U.S. Department of the Interior
BUREAU OF LAND MANAGEMENT

| Well Name: CLAWHAMMER 33-28-21 FED COM | Well Location: T26S / R30E / SEC 33 / LOT L2 / | County or Parish/State: |

Notice of Intent

Type of Action: APD Change

Variance Request

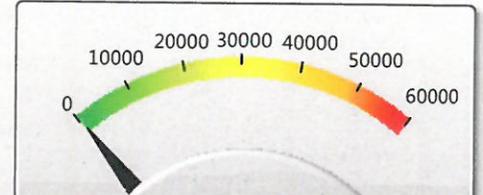
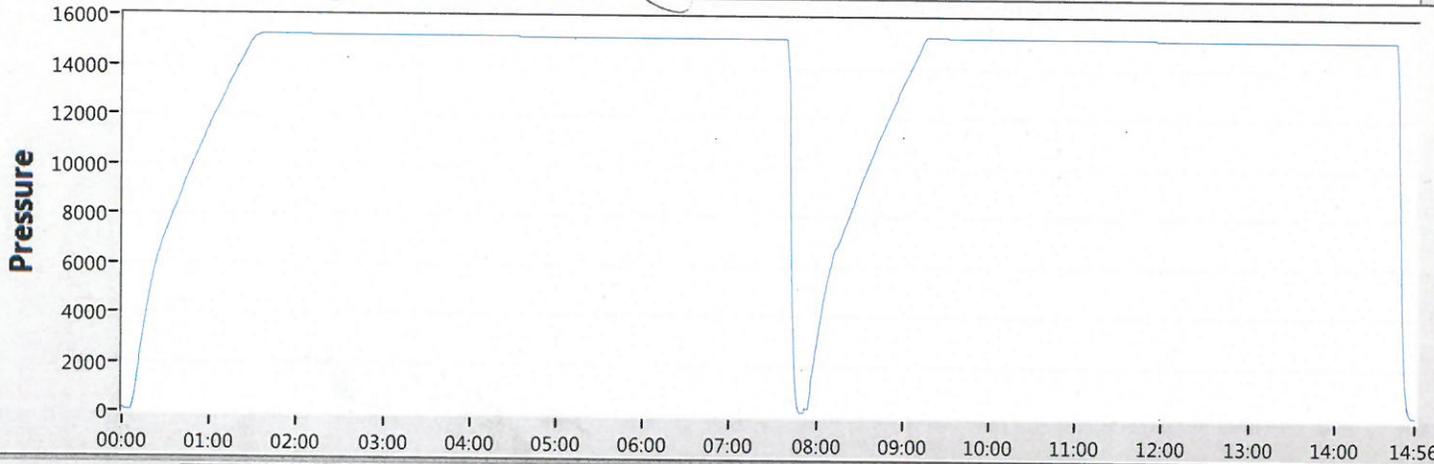
Devon Energy requests to only test BOP connection breaks after drilling out of surface casing and while skidding between wells which conforms to API Standard 53 and industry standards. This test will include the Top Pipe Rams, HCR, Kill Line Check Valve, QDC (quick disconnect to wellhead) and Shell of the 10M BOPE to 5M for 10 minutes. If a break to the flex hose that runs to the choke manifold is required due to repositioning from a skid, the HCR will remain open during the shell test to include that additional break. The variance only pertains to intermediate hole-sections and no deeper than the Bone Springs Formation where 5M BOP tests are required. The initial BOP test will follow OOGO2.III.A.2.i, and subsequent tests following a skid will only test connections that are broken. The annular preventer will be tested to 100% working pressure. This variance will meet or exceed OOGO2.III.A.2.i per the following: Devon Energy will perform a full BOP test per OOGO2.III.A.2.i before drilling out of the intermediate casing string(s) and starting the production hole, before starting any hole section that requires a 10M test, before the expiration of the allotted 14-days for 5M intermediate batch drilling or when the drilling rig is fully mobilized to a new well pad, whichever is sooner. We will utilize a 200' TVD tolerance between intermediate shoes as the cutoff for a full BOP test. The BLM will be contacted 4hrs prior to a BOPE test. The BLM will be notified if and when a well control event is encountered. Break test will be a 14 day interval and not a 30 day full BOPE test interval. If in the event break testing is not utilized, then a full BOPE test would be conducted.

1. Well Control Response:
 1. Primary barrier remains fluid
 2. In the event of an influx due to being underbalanced and after a realized gain or flow, the order of closing BOPE is as follows:
 - a) Annular first
 - b) If annular were to not hold, Upper pipe rams second (which were tested on the skid BOP test)
 - c) If the Upper Pipe Rams were to not hold, Lower Pipe Rams would be third
